**PLANNING AND DEVELOPMENT SERVICES STAFF REPORT**

**For Planning Commission Meeting of September 7, 2016**

**SUBJECT: Circle K Site Plan for City Council Approval  
(1420 East Stadium Boulevard)  
File No. SP15-014**

**SUBJECT: Circle K Site Plan for City Council Approval  
(1420 East Stadium Boulevard)  
File No. SP11-037**

SHEET NO.:  
**C-3**

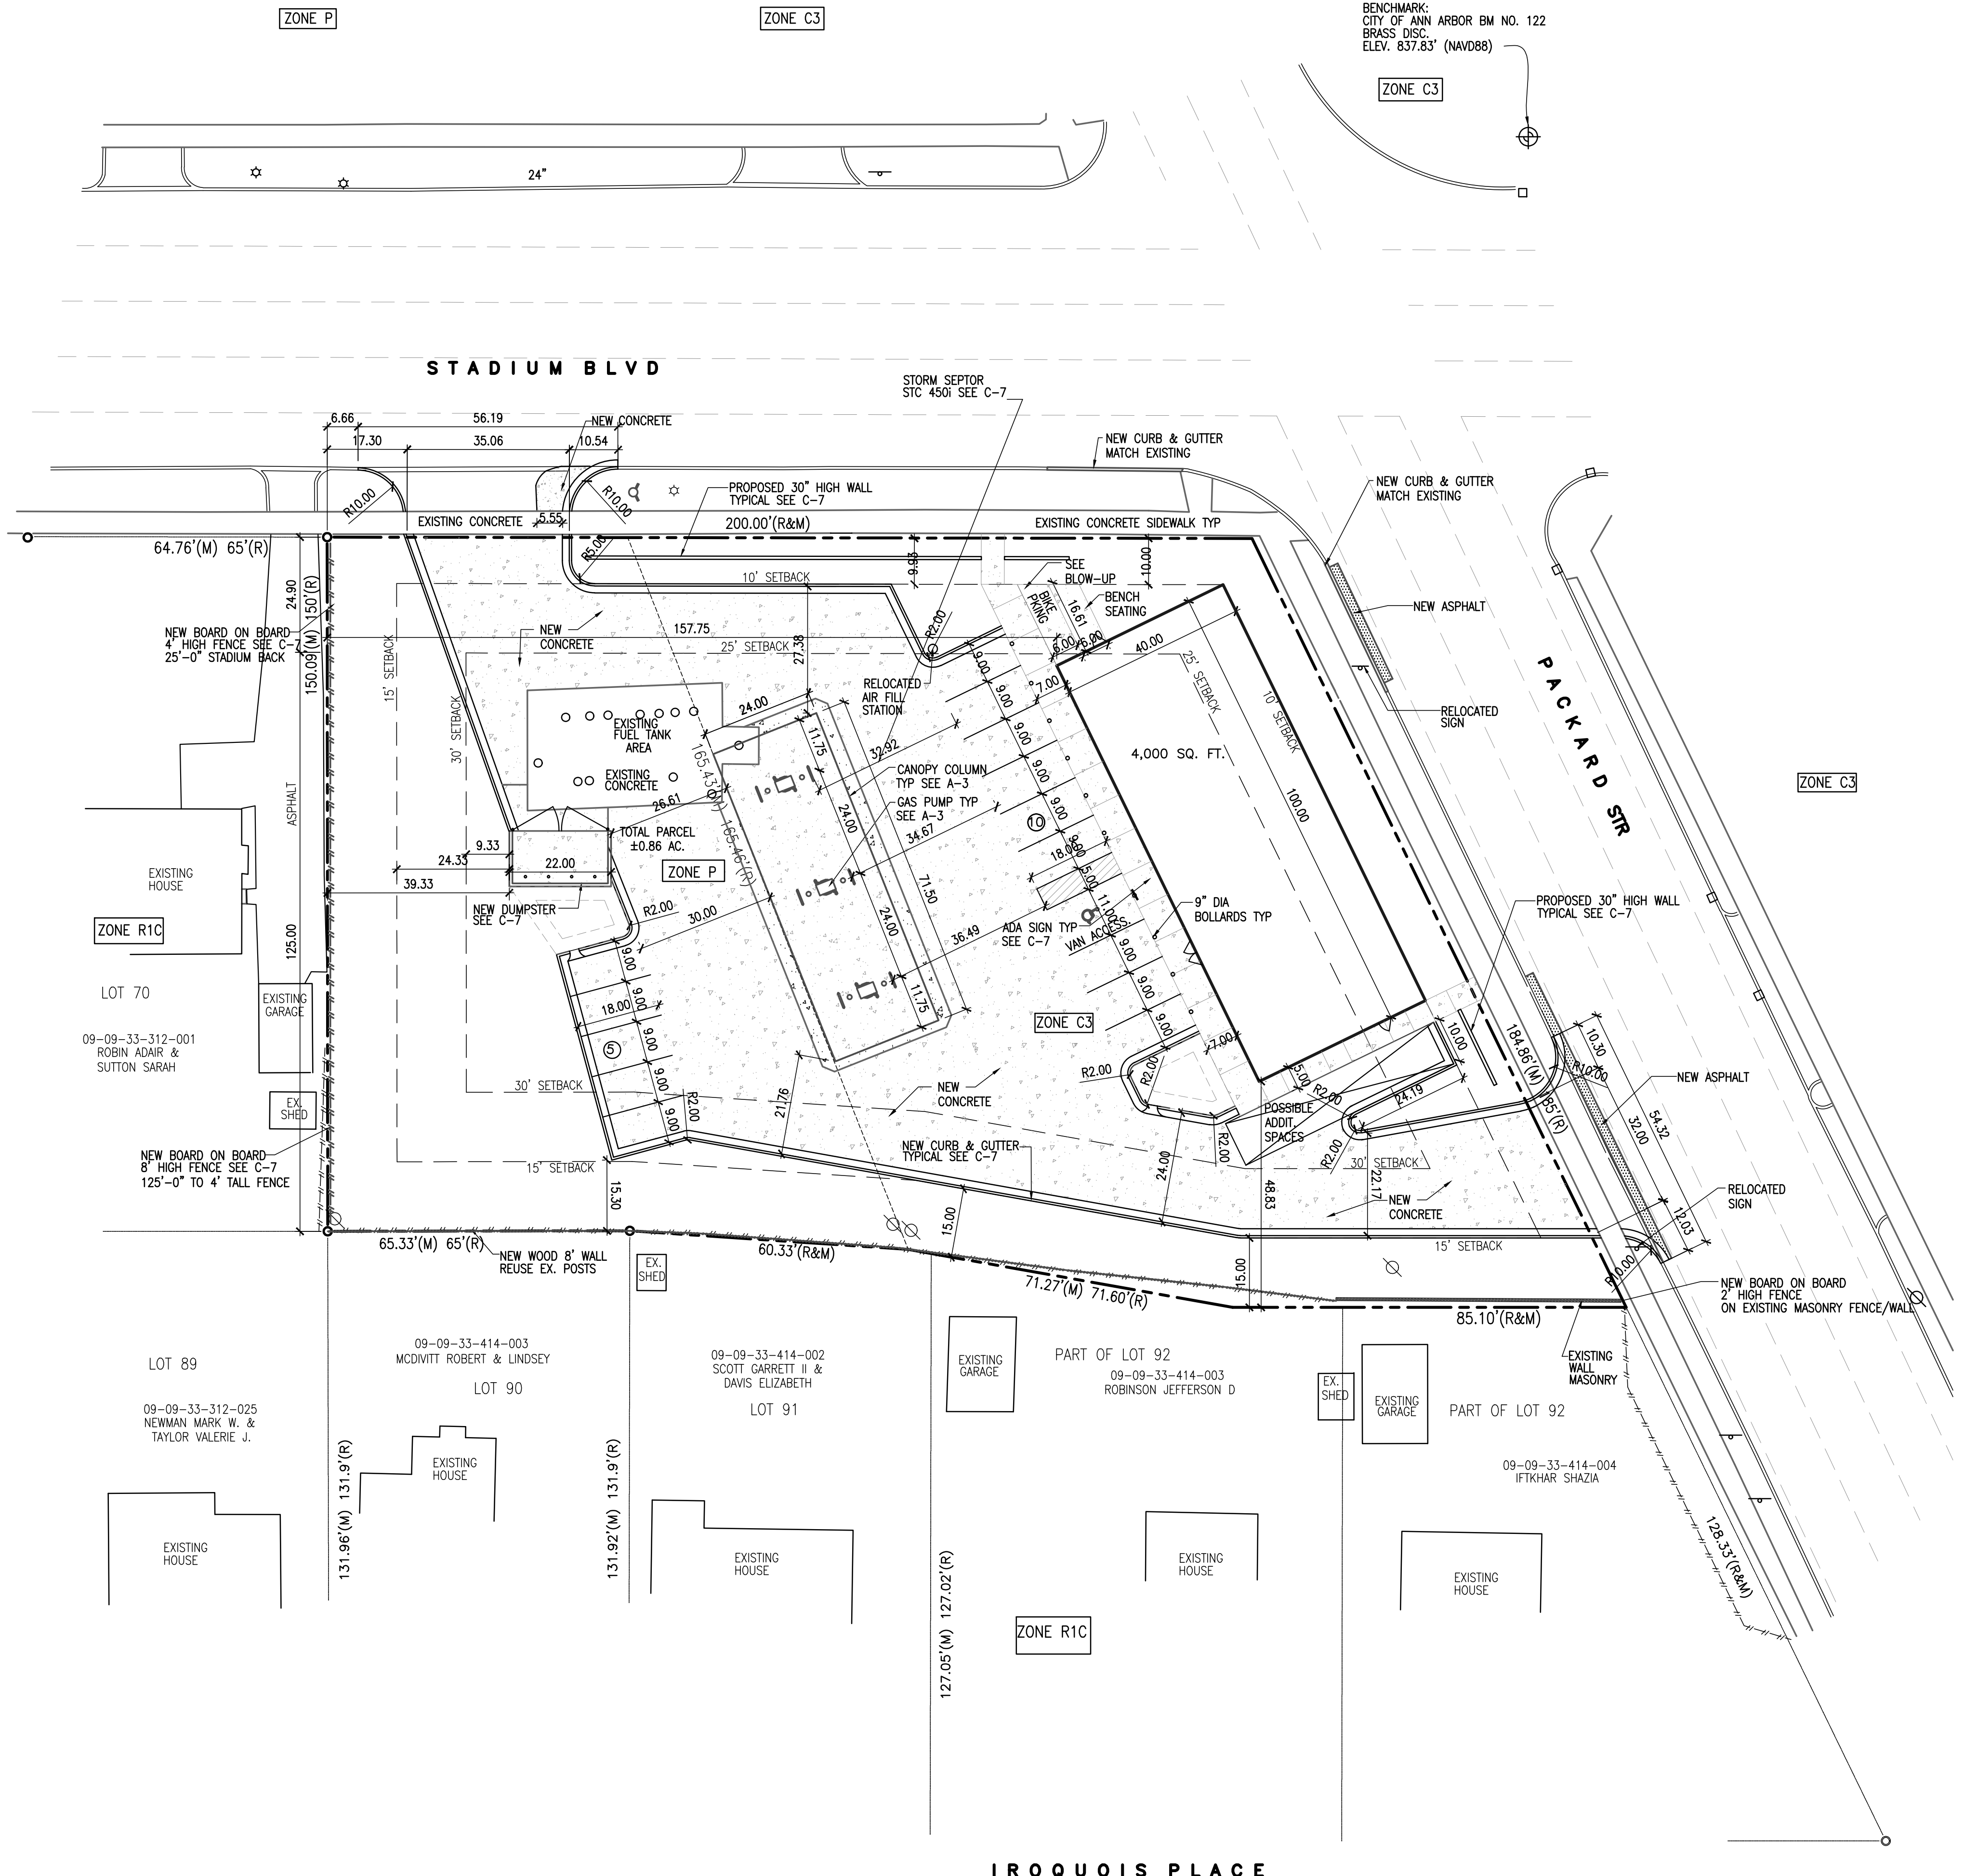
This site plan was postponed at the March 15, 2016 Planning Commission meeting in order to allow the petitioner time to address concerns mentioned by the Planning Commission. These concerns included: the location of the building within the rear setback (variance required), site lighting, canopy structure, and the driveway proximity to the intersection of Packard and West Stadium intersection.

The petitioner has responded by redesigning the site and moving the building toward the corner of Packard and East Stadium, utilizing the 10 foot minimum setback along Packard. As a result, the driveway to Packard has been shifted to the south, away from the intersection. Moving the building toward the intersection also eliminated the need for a rear setback variance; however, variances for both driveway widths are still required. The number of gas pumps has been reduced by two for a total of 6 pumps. The petitioner has also revised the supplemental photometric study that was submitted. All lights on the canopy are flush with the canopy ceiling at 15 feet in height. The canopy has a three foot high fascia that wraps the canopy and extends one foot below the height of the lights to provide additional screening.

The site plan as proposed requires that variances for both driveway widths be granted from the Zoning Board of Appeals (ZBA). The drives are designed wider than the maximum required width in order to allow for solid waste and gasoline tanker trucks to enter the site safely and most efficiently. Due to the unique constraints of the deed restriction for the western third of the site, vehicle circulation and the requirement for employees to have direct eye contact with the gas pumps, the petitioner feels the proposed site plan is the best to minimize impacts, including light pollution, to the neighborhood and address Planning Commission concerns.

Planning – Over the last couple years, the petitioner has worked through many different versions of the plan in order to address concerns of the neighborhood and city staff, while working with unique constraints of the proposed use and existing deed restriction. In March 2016, Planning Commission offered comments which resulted in additional revisions and the redesigned plan. Staff does support the site plan and requested variances for driveway widths as presented. However, staff has expressed concerns about the building elevations facing East Stadium and Packard. While the use of materials and varied elevations offers some relief from a 'blank wall', staff has recommended the use of real windows, instead of spandrel glass, and possibly public entrance along Packard to help activate the Packard frontage. The building will be constructed with brick and stone elements with a flat roof. The majority of vehicle parking is facing the building that will help to screen the neighborhood from headlights as well as some site lighting.

Site lighting, in particular canopy lighting, was a major concern for the adjacent neighbors. In order to address this concern, the petitioner has lowered the canopy to the minimum height possible and recessed canopy lighting and will not light the exterior of the canopy. They have also submitted an extensive photometric plan conducted by an outside consultant. The plan details lighting levels and fixtures that reduce light pollution beyond the code requirement. The lighting plan uses fixtures and screening to reduce off site light trespass; these elements are part of the submitted site plan and must be constructed as shown on the plan.

SHEET NO.: L-1

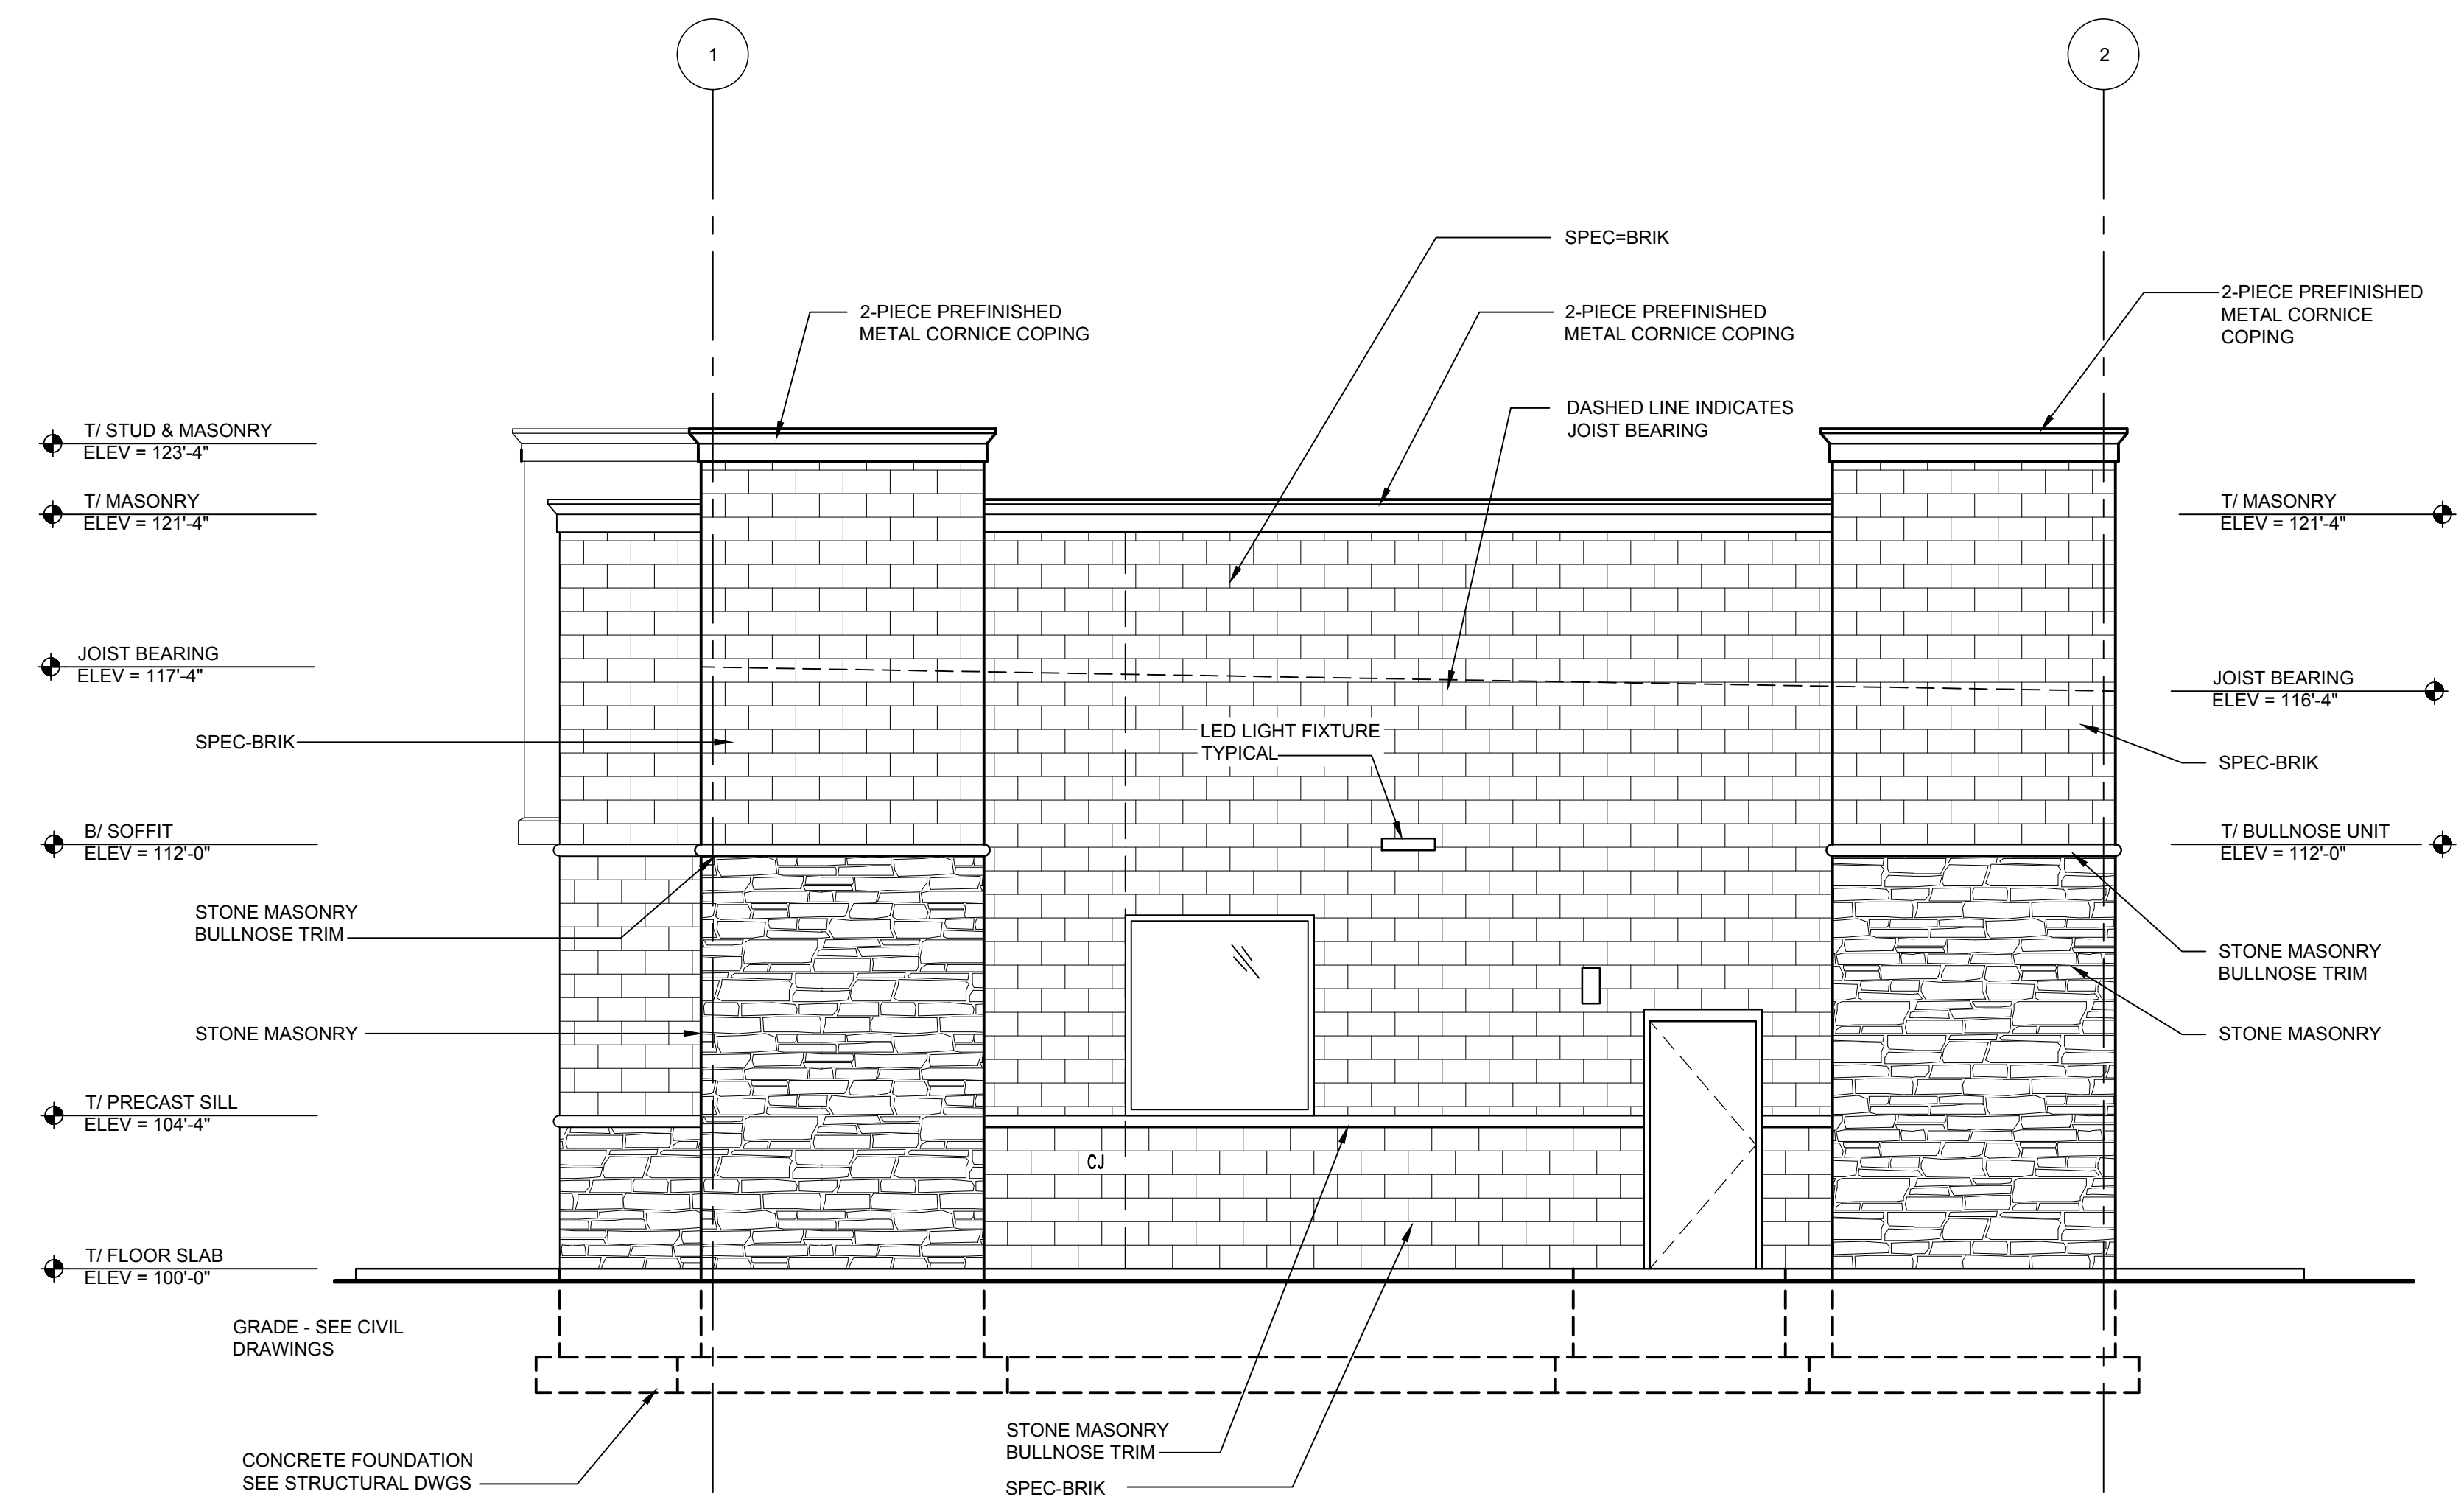
Systems Planning (Landscaping) – It appears several trees adjacent to the southern property line could be saved through construction. Preservation of these trees would also align with some requests of some adjacent property owners. While the petitioner has shown the required mitigation for these trees, if the trees are saved, the overall mitigation required would be reduced accordingly.
